## Brisbane Central Business District Bicycle User Group

Please accept this as the Brisbane Central Business District Bicycle User Group (CBD BUG) submission regarding the proposed development at the Eagle St Pier under application number A006210576 which is an amendment to A005477682. In line with the CBD BUG's standard practice this submission will only outline concerns with the proposal and how it impacts on cycling.

Figure 1 – Eagle St – Existing Conditions

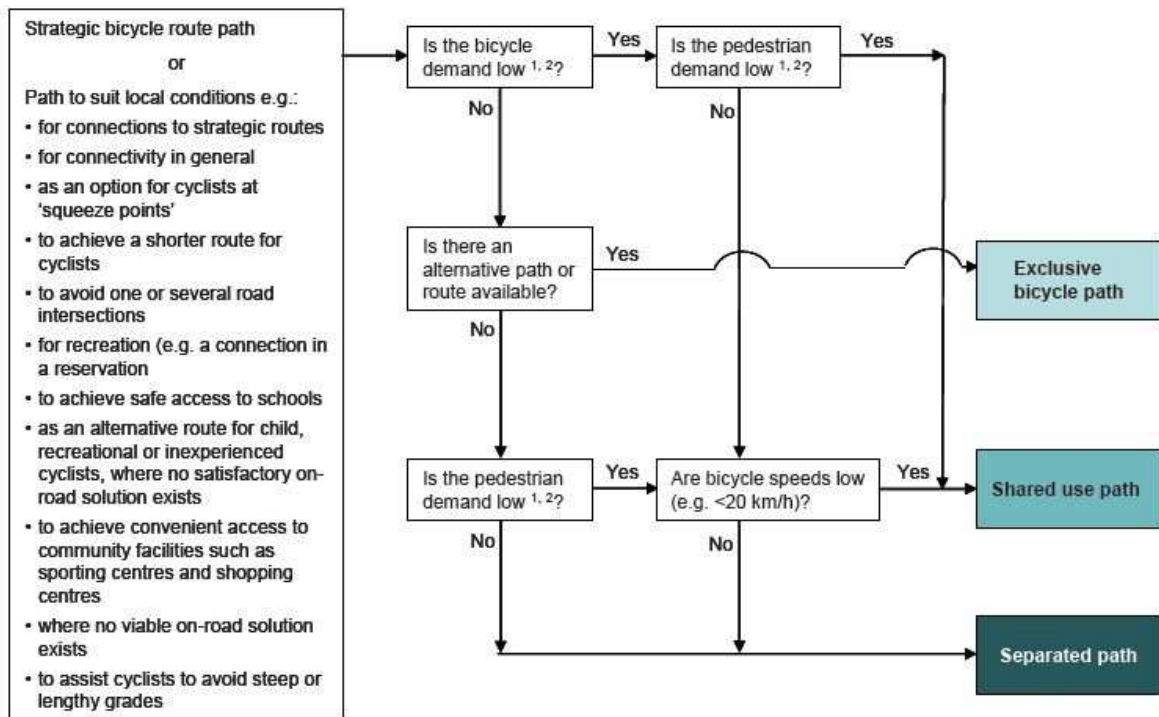
The existing Riverwalk forms a vital active transport function for people traveling to/from/through Riverside to/from/through the Brisbane City Gardens. It is the only CBD corridor where there is no risk of conflict with motor vehicles. Currently, the Riverwalk through the Eagle Street Pier splits into an upper and a lower path (Figure 1). The upper path is predominately used by people wishing to linger and stroll. The lower path is predominately used by people to travel through the precinct whether they be on foot or bicycle. While the lower path is a substandard width, the separation of functions removes much conflict which would exist if the two paths had been built as one. Currently, the upper path is a minimum width of 3m and the lower path a minimum width of 2.5m providing a combined width of 5.5m for the Riverwalk.

**Figure 6 - TMR**

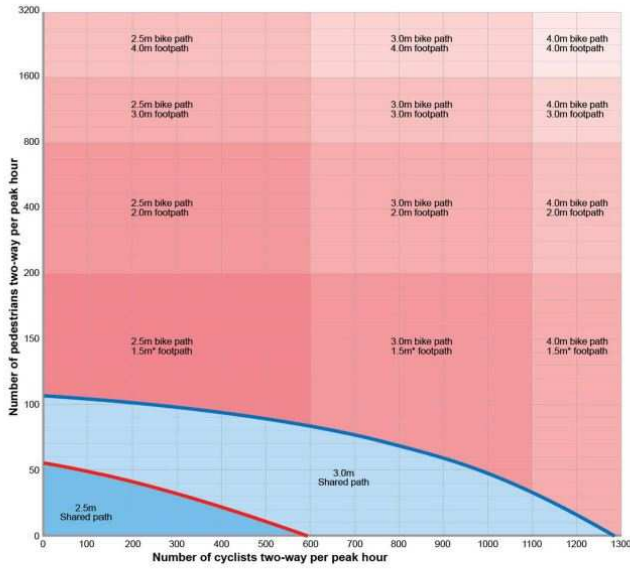
**2c.1.** TMR supplement to Part 6a Figure 6 and Figure 7 both show that even at current volumes a separated path is recommended
